INTEROFFICE MEMORANDUM

**TO:** JOHN HOGAN  
**FROM:** KEN HORSFALL  
**SUBJECT:** COOLING TOWER SIZING CODE  
**DATE:** FEBRUARY 16, 2004  
**CC:**

# Chiller Plant Energy Use 76/86 Tower Design

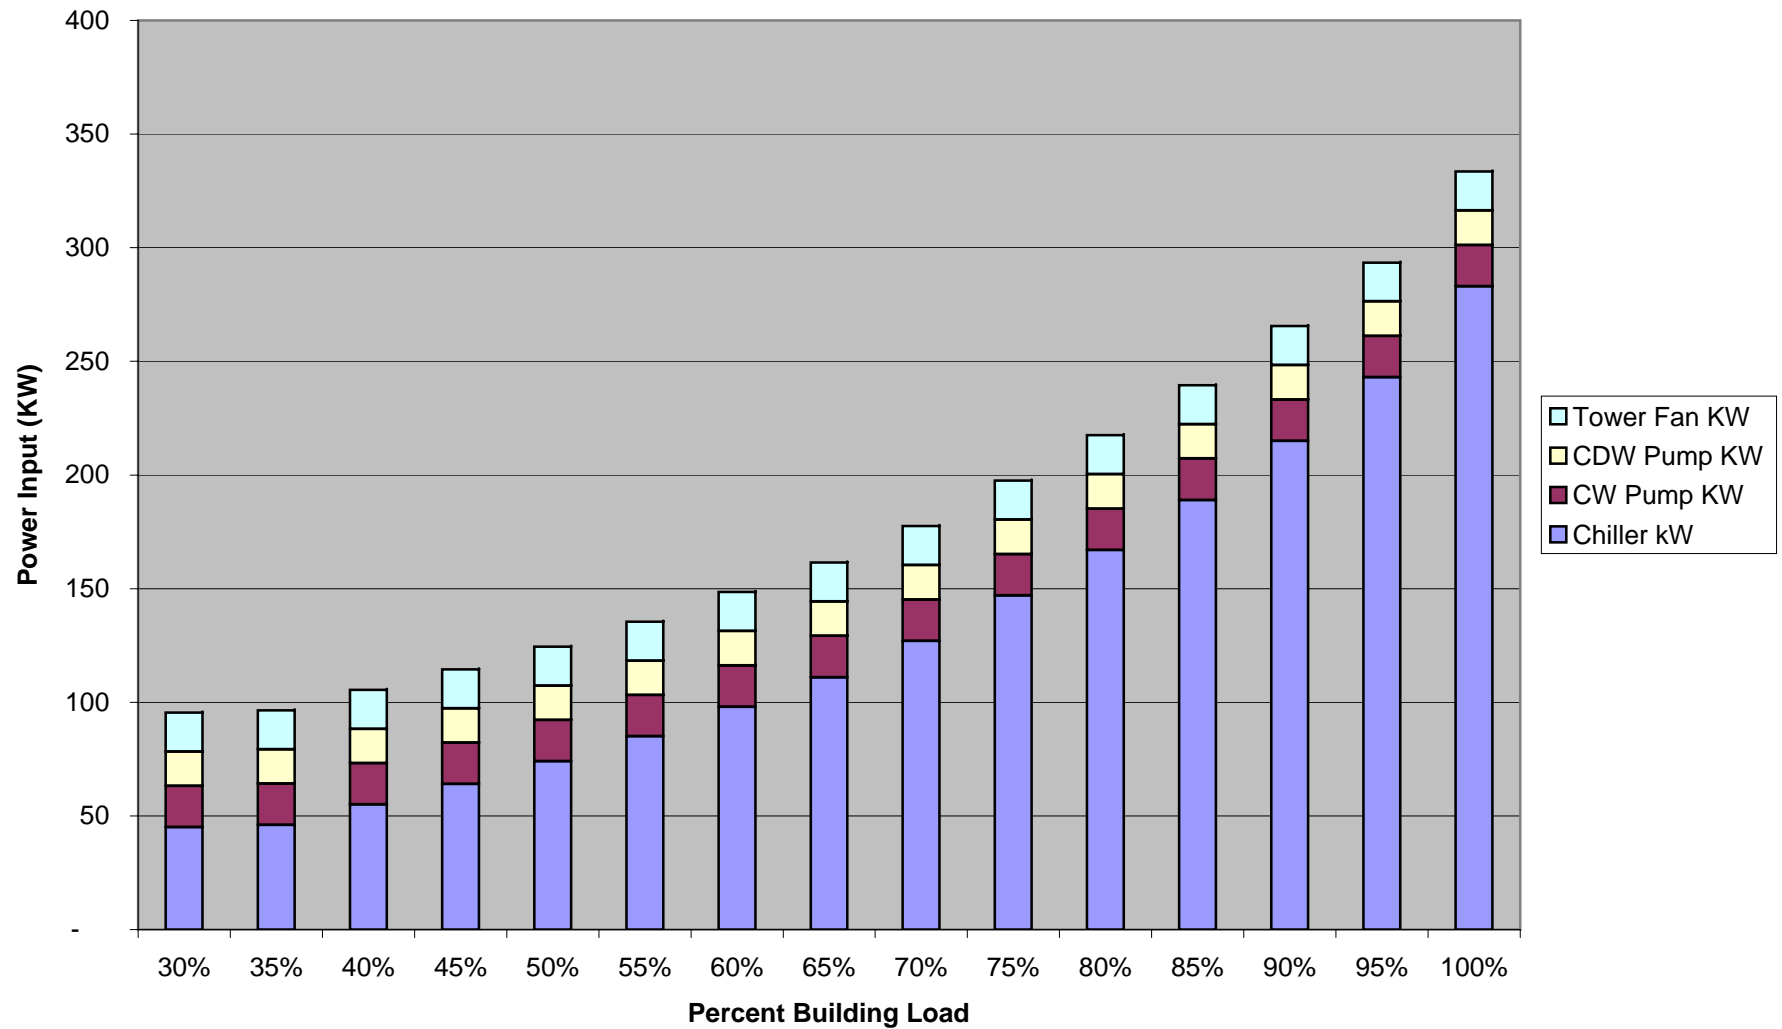
In considering energy efficiency in a chilled water cooling plant, one of the best ways to save energy is to reduce the power requirement of the water chiller. Although pumps and tower fans have an impact on the overall energy use, it is usually a small portion of the total power input at plant loads above 30% (see attached chart).

## Cooling Tower Efficiency

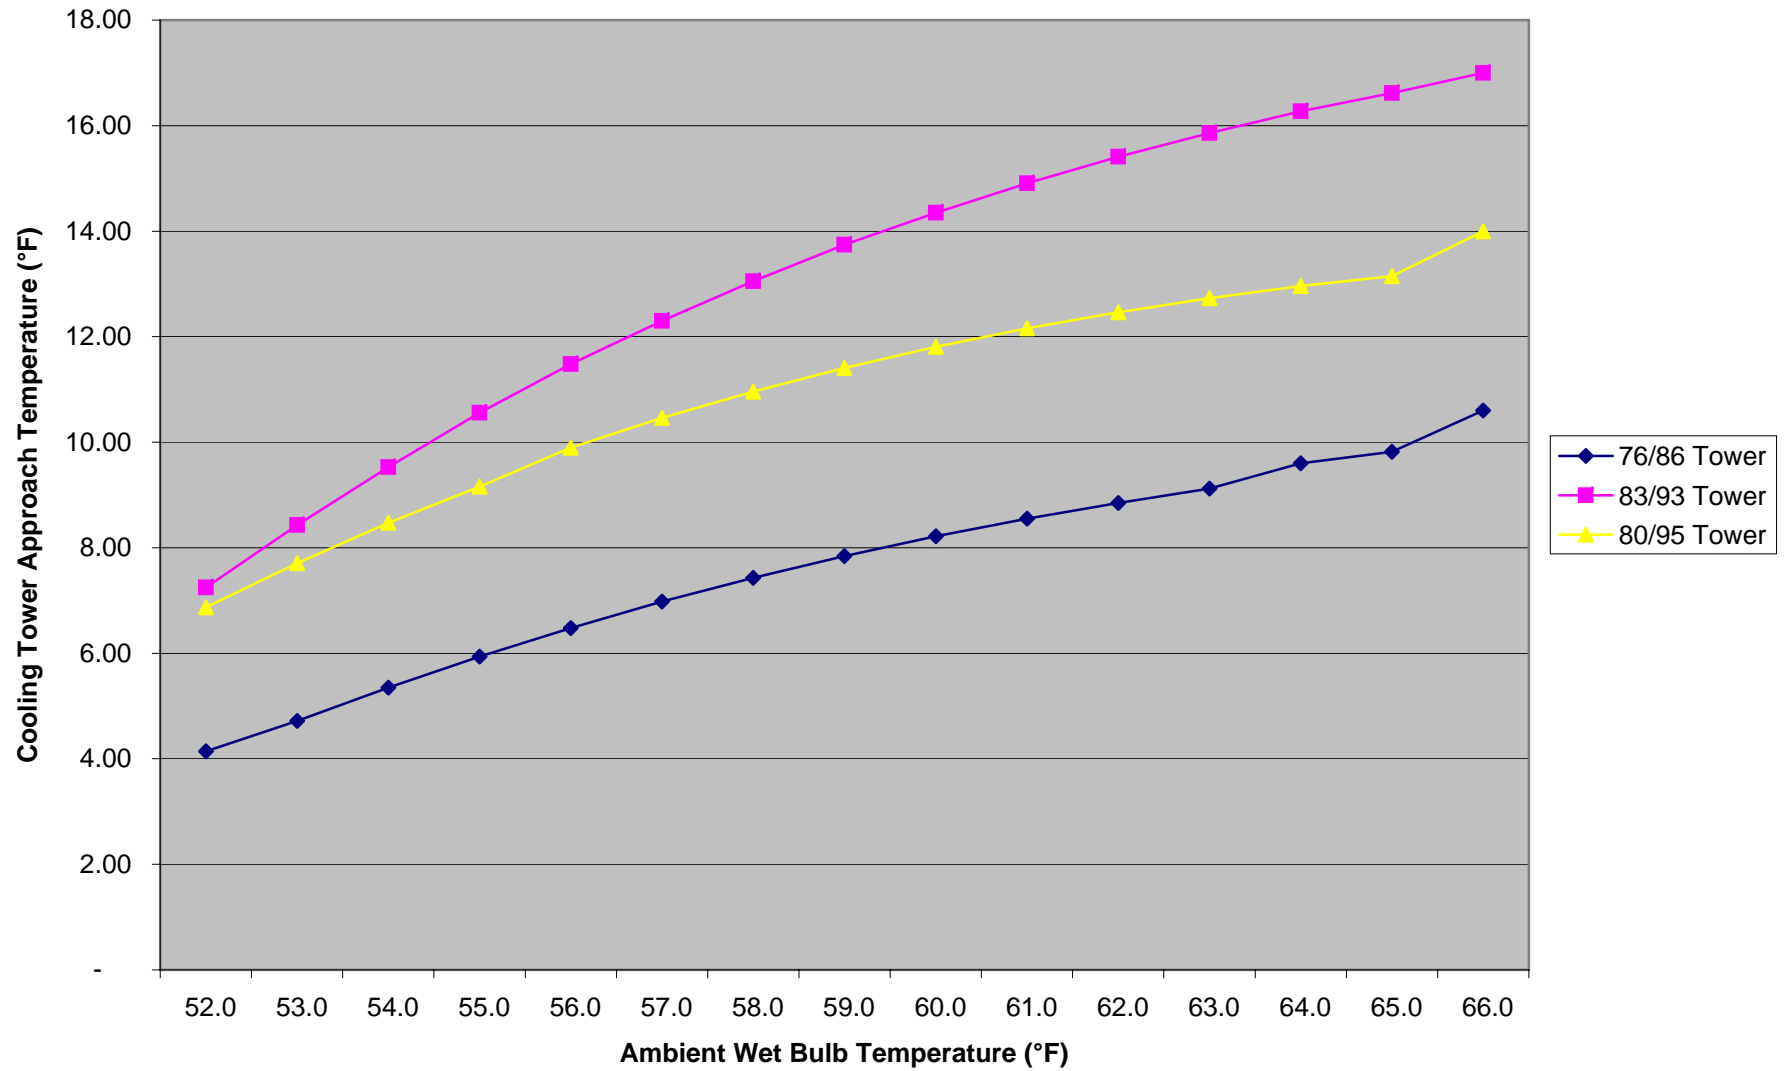
The measure of cooling tower efficiency is the approach temperature, i.e. the difference between the ambient wet bulb temperature and the water temperature leaving the tower. The attached chart shows the approach temperature of three different tower designs as a function of ambient wet bulb temperature. It is clear from this chart that a tower designed for better efficiency (small approach) at full load maintains the ability to outperform the other towers at lower ambient temperatures.
